Technical Bulletin / Safety Alert

Unique ID No: DES2014-TBSA-07

Subject: Nautitech Methane Shutdown Systems – Solenoid Valve

Date: 19th December 2014

Figure 1: Nautitech Methane Shutdown System Solenoid Valve
(VLI Part No. 0601-50028)

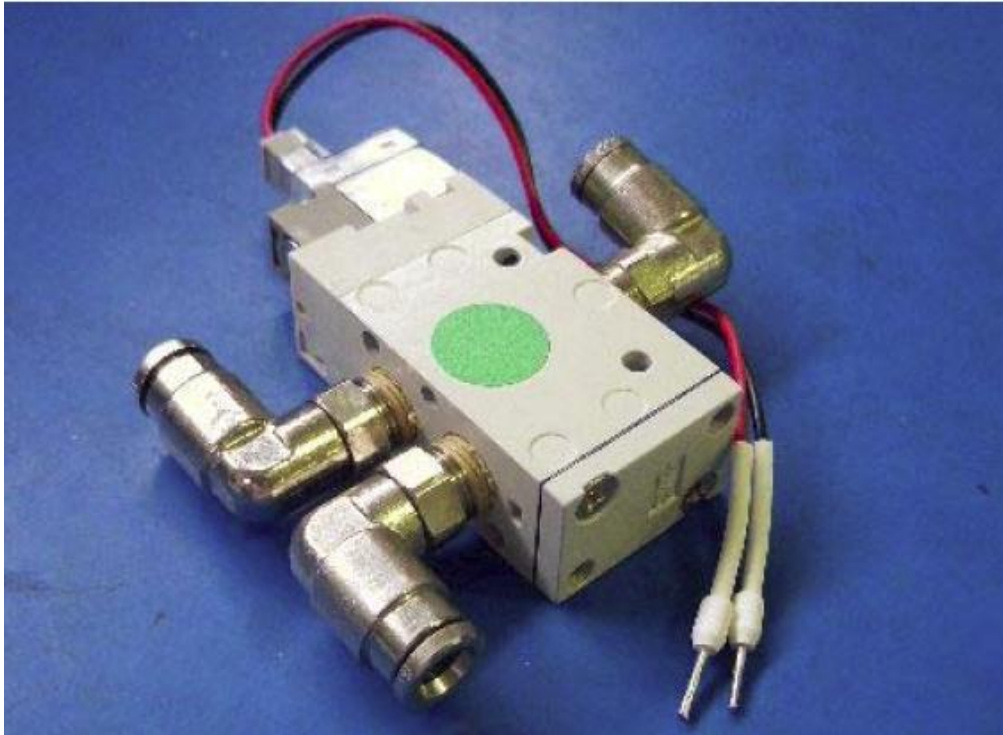
VLI advises that the Nautitech Methane Shutdown System Solenoid Valve (VLI Part No. 0601-50028) was recently identified to have failed in service to the open position on three (3) separate VLI machines at the same Queensland coal mine. Two (2) failures occurred on separate VLI JUG-A-0 UL/UV machines and one (1) failure occurred on a VLI Driftrunner.

When the Nautitech Methane Shutdown System Solenoid Valve fails to the open position, the automatic shutdown of the diesel engine system (due to detection of methane gas concentration exceeding 1.25%) via the pneumatic shutdown circuit cannot occur. The Nautitech Methane Shutdown System will however continue to display methane gas concentration levels and provide indication via a warning light system. The VLI diesel engine system manual shutdown function remains unaffected.

The failed Nautitech Methane Shutdown System Solenoid Valves were disassembled and inspected and found to have failed in the open position due to wear in the valve body spool bore. These solenoid valves form part of the pneumatic shutdown circuit of the diesel engine system, which includes machine specific air filtration and water separation devices to minimise pneumatic circuit component contamination, wear and deterioration. The end user that has reported the recent solenoid valve failures has confirmed that each of the relevant vehicles was installed with air filtration compliant with the OEM design. Each of the valves had reportedly been in service in excess of 4,000hrs (machine run hours). After further examination and comparison with new solenoid valves, VLI has concluded that the failed solenoid valves have exceeded their serviceable life.

Previously the recommended service life of the Nautitech Methane Shutdown System Solenoid Valve was not defined. However based on the recent occurrences and subsequent investigation, VLI and Nautitech now recommend that the solenoid valve is replaced at a maximum service interval of 4,000hrs (machine run hours). Consideration may need to be given to site specific conditions when determining the replacement interval of the solenoid valve.

Where Nautitech Methane Shutdown Systems are installed to VLI equipment, VLI and Nautitech recommend that the Nautitech Methane Shutdown System Solenoid Valve is replaced at maximum service intervals of 4,000hrs (machine run hours).
